# VOLUME I - RESPONSES TO COMMENTS

FINAL ENVIRONMENTAL IMPACT REPORT  
**DENNISTON / SAN VICENTE WATER SUPPLY PROJECT**  
**COASTSIDE COUNTY WATER DISTRICT**

**FEBRUARY 2015**

Figure 4. Groundwater flow model results. Arrows show direction of groundwater flow.

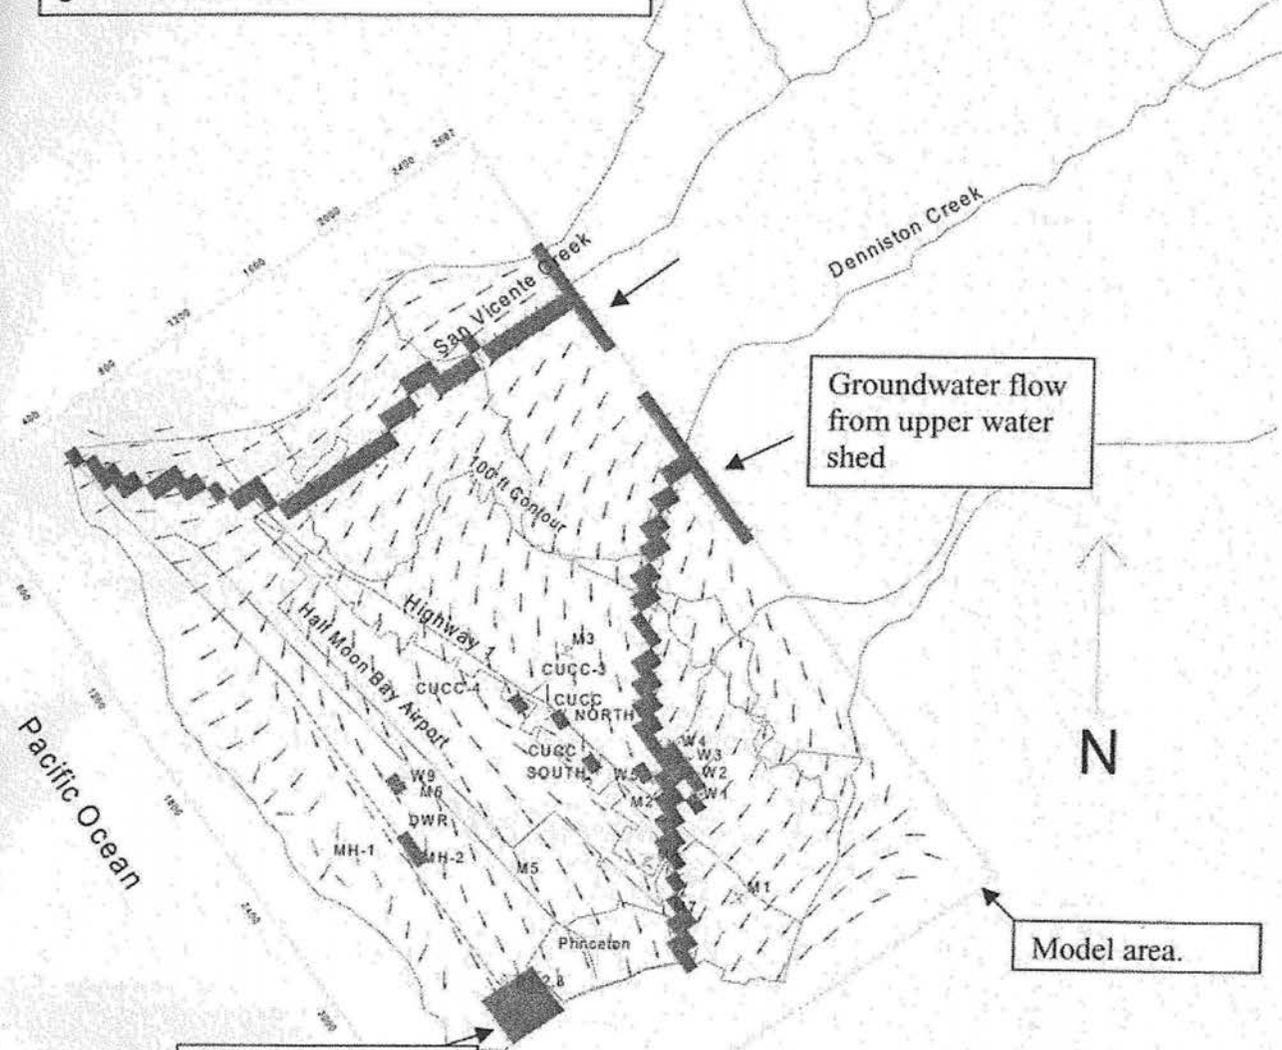
1. CCWD, per their existing water rights permit, may divert from San Vicente all year, but between June and October only if there is a wetted channel at the downstream boundary of Torello Ranch (at Etheldore Street). The DEIR states in its analysis of impacts that some unquantifiable amount of streamflow will bypass the diversion based on the design of the structure. We agree that it is reasonable and practical for the project to offer a small amount of leeway for bypass flows in order to avoid downstream impacts highlighted in this comment letter; we therefore have presented information that this small amount of bypass flow (needed to maintain a wetted channel) be included as year-round mitigation and as a permit condition. In addition, to minimize surface-water and groundwater impacts highlighted in this comment letter, the wetted channel condition should be required through the reach downstream of the diversion to the west boundary of the aquifer, generally considered at the Seal Cove fault. We view this as an appropriate modification in light of new data presented and interpreted in the DEIR that surface water from Denniston and San Vicente Creeks provides "very limited" recharge to the Airport Aquifer.<sup>7</sup> If this newly proposed notion proves to be reasonably correct, then this recommendation to divert from San Vicente only if there is a wetted channel at the Seal Cove fault would not be notably different from the existing requirement. However, if the reach downstream of the diversion is important for recharge to the Airport Aquifer then the suggested modification would mitigate any potential impacts.

Enclosure: Figure illustrating groundwater flow modeling results by HydroFocus Inc., 1999
